ADMINISTRATIVE APPLICATION CHECKLIST

Re: Form C-108:
Application to Amend Order No. PMX-264
North Hobbs G/SA Unit No. 442 (API No. 30-025-28878)
1200' FSL & 220' FEL, Unit P, Section 13, T-18S, R-37E
North Hobbs G/SA Unit No. 411 (API No. 30-025-12783)
330' FNL & 330' FEL, Unit A, Section 23, T-18S, R-37E
Both in Lea County, New Mexico

APPLICATION FOR AUTHORIZATION TO INJECT

Occidental Permian Ltd.
North Hobbs G/SA Unit No. 442
API No. 30-025-28878
1200' FSL & 220' FEL (Unit P)
Section 13, T-18 South, R-37 East, NMPM
Lea County, New Mexico
Date Drilled: October, 1984

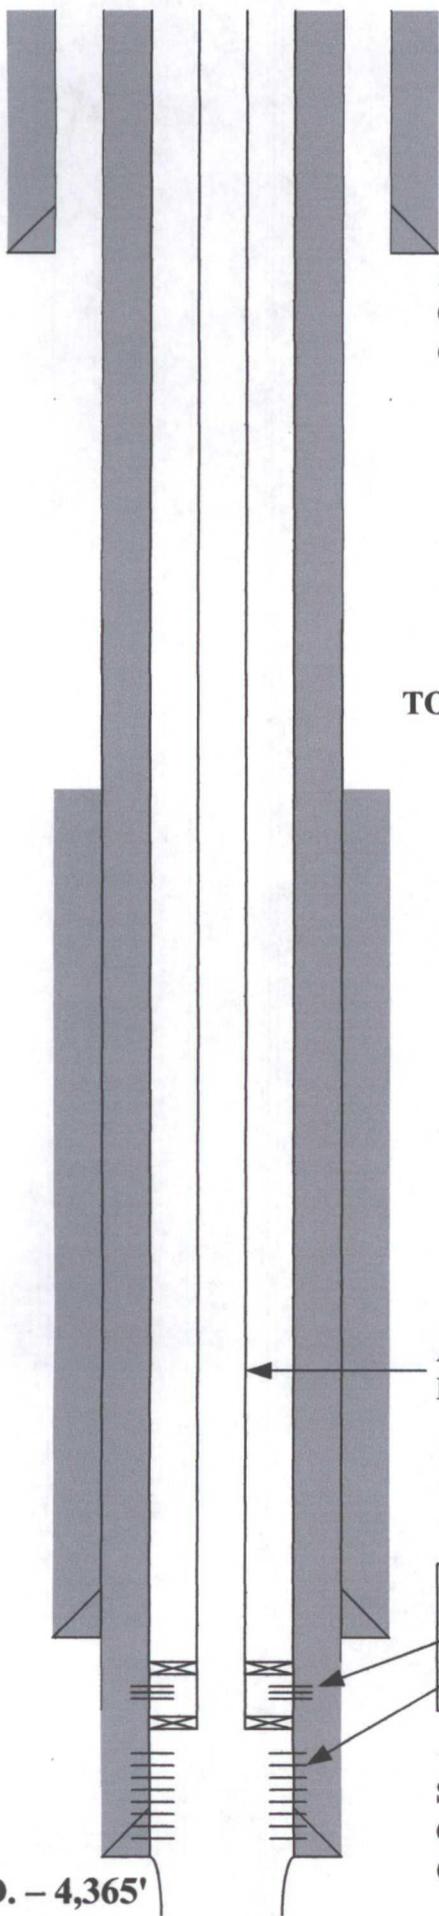
**Current Injection Interval:
4,146'-4,293' Perforated**

**Proposed Injection Interval:
4,146'-4,370' Perforated**

Occidental Permian Ltd.
North Hobbs G/SA Unit No. 411
API No. 30-025-12783
330' FNL & 330' FEL (Unit A)
Section 23, T-18 South, R-37 East, NMPM
Lea County, New Mexico
Date Drilled: May, 1951

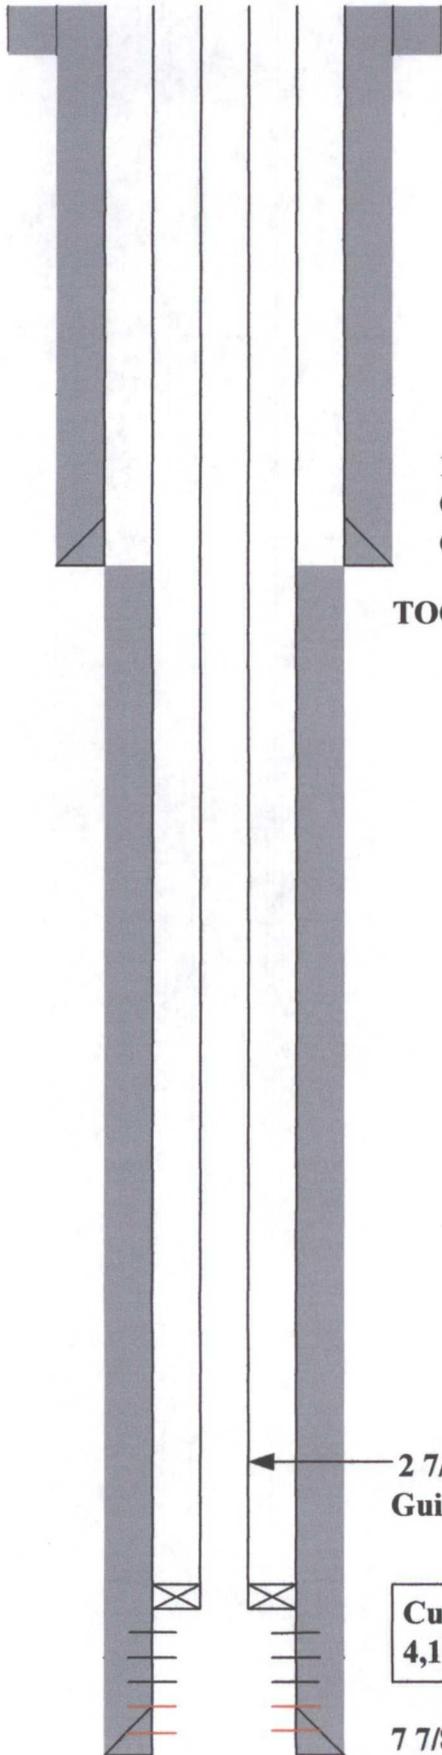
Current Injection Interval:
4,225'-4,252'-Currently Isolated Perfs.
4,263'-4,323' Open Perfs.

Proposed Injection Interval:
4,000'-4,323' Perforated
4,323'-4,365' Open-Hole
